CHILDREN'S HOSPITAL  
OF ORANGE COUNTY

TOWER II

LEVEL 7 REFLECTED  
CEILING PLAN

A4.71

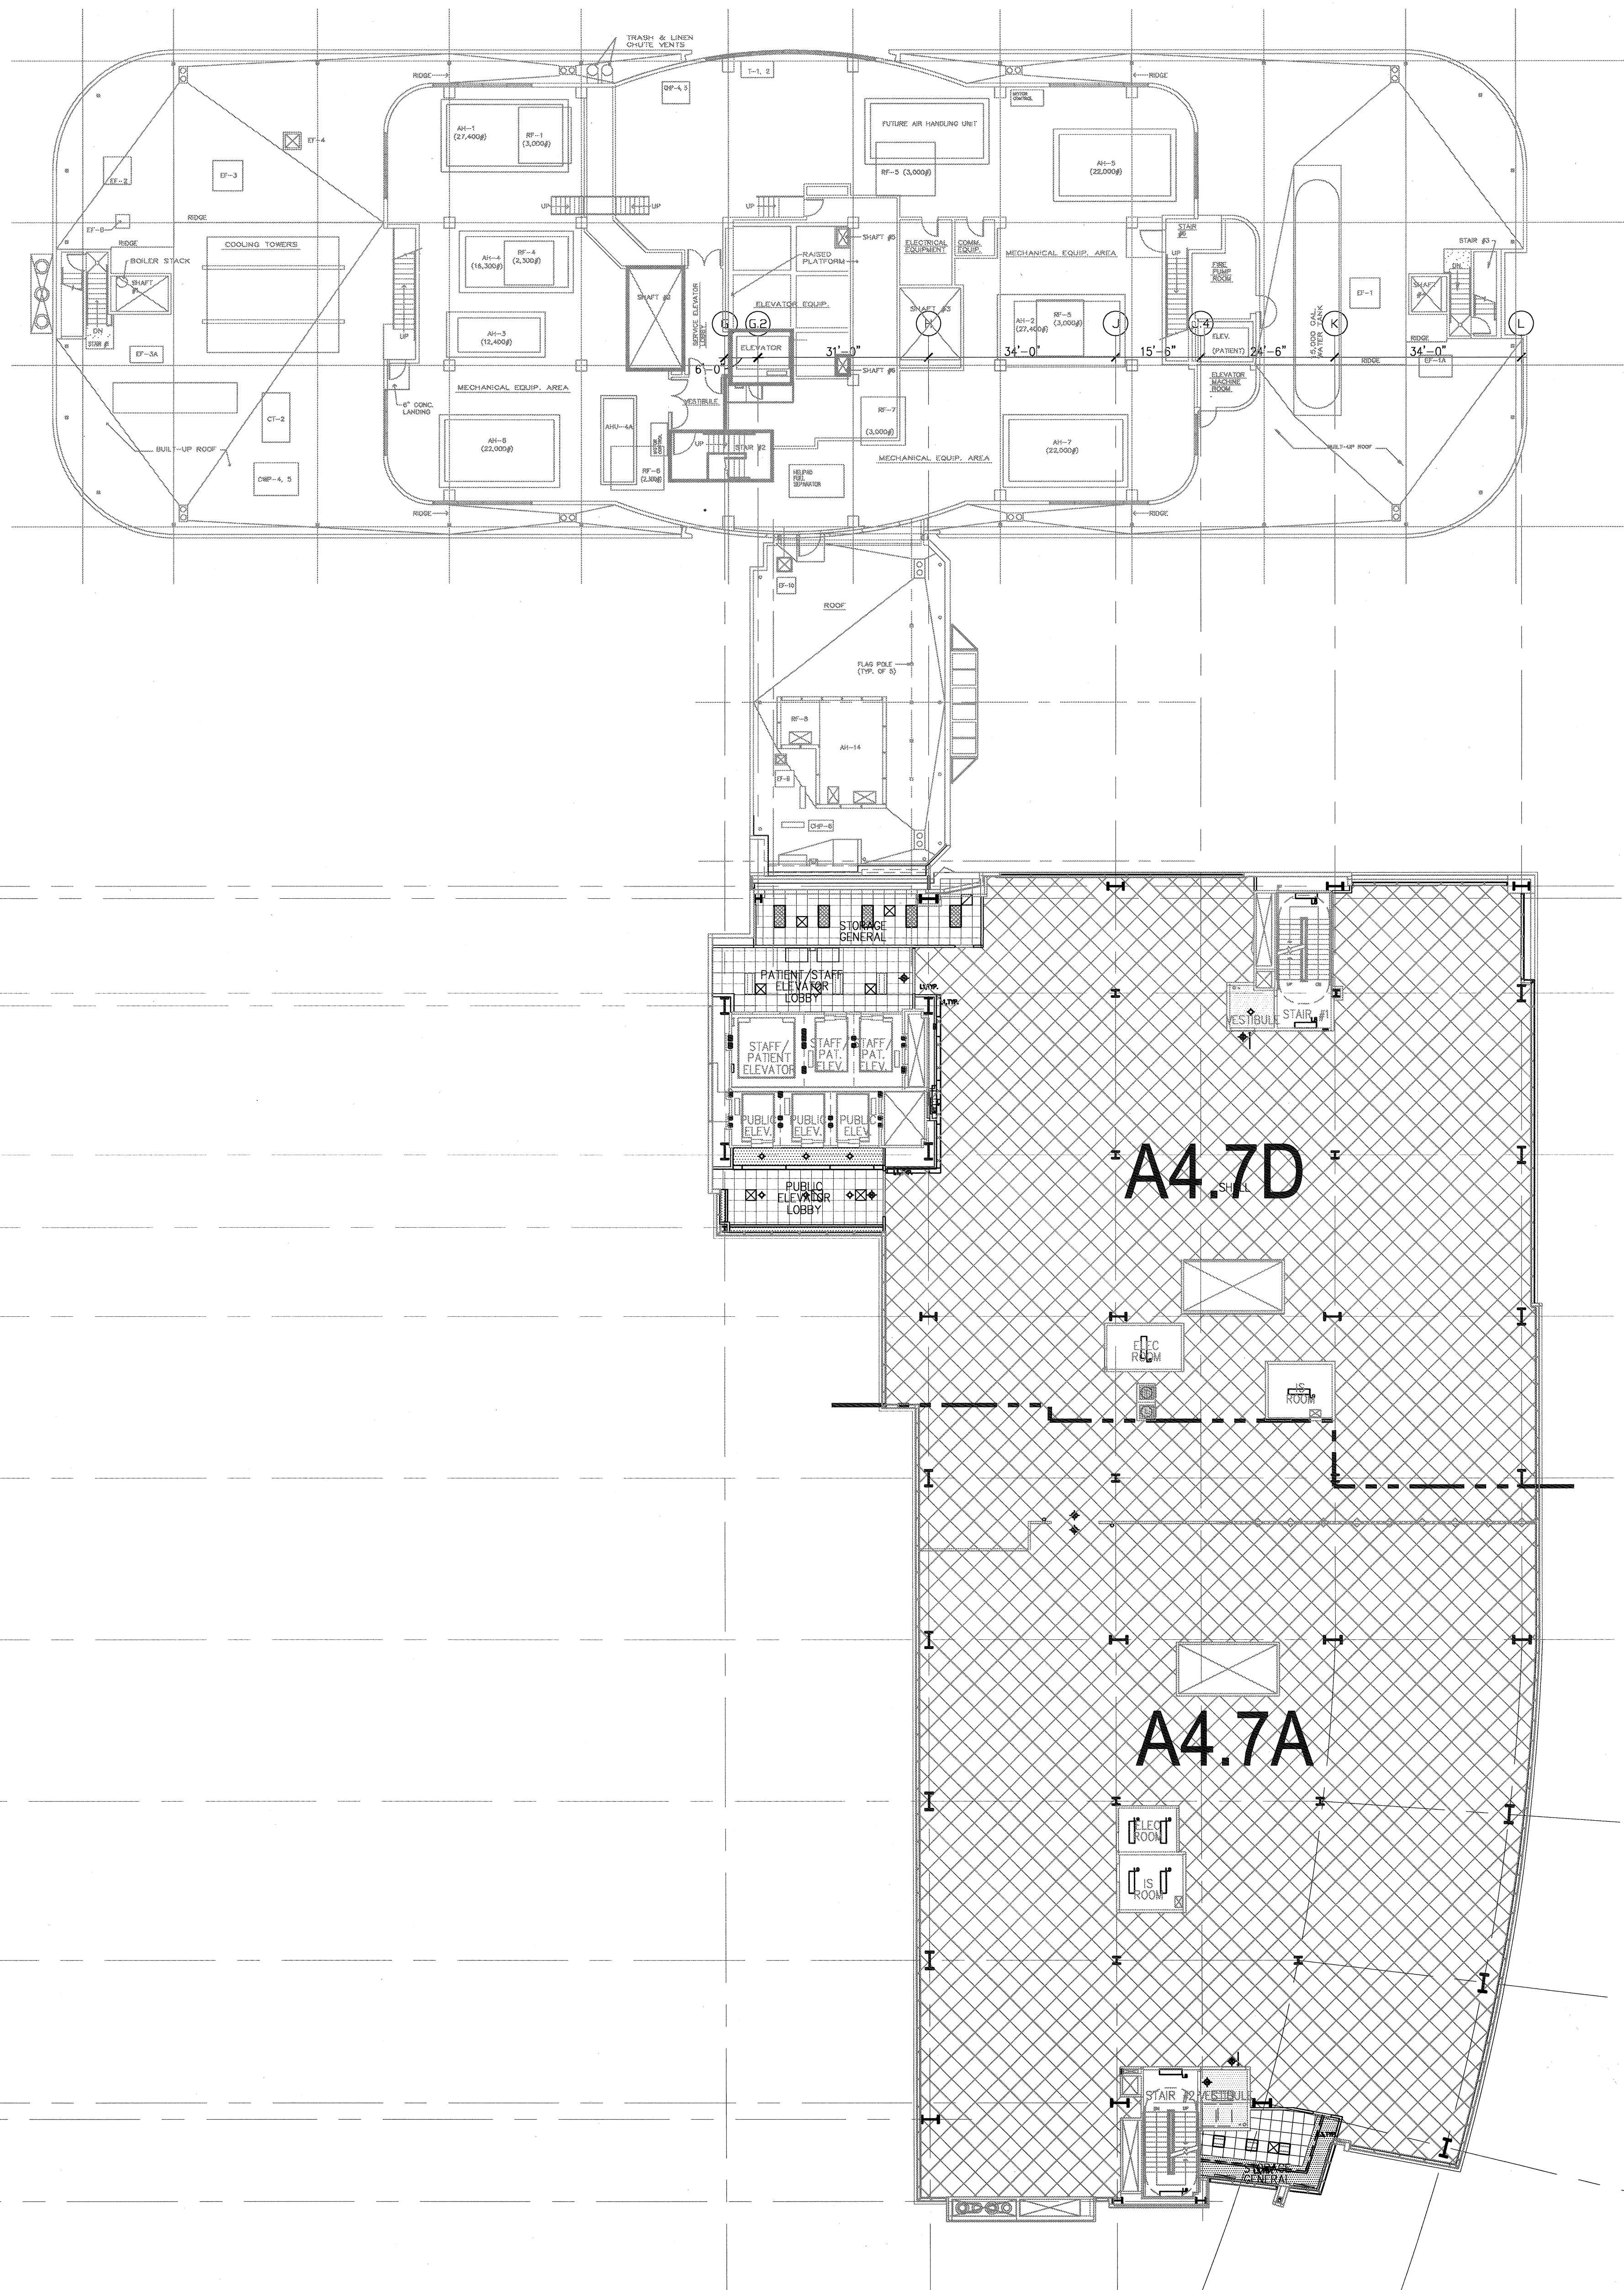
RFI 1018  
Refer to electrical lighting plans for light  
fixture locations in shell space.
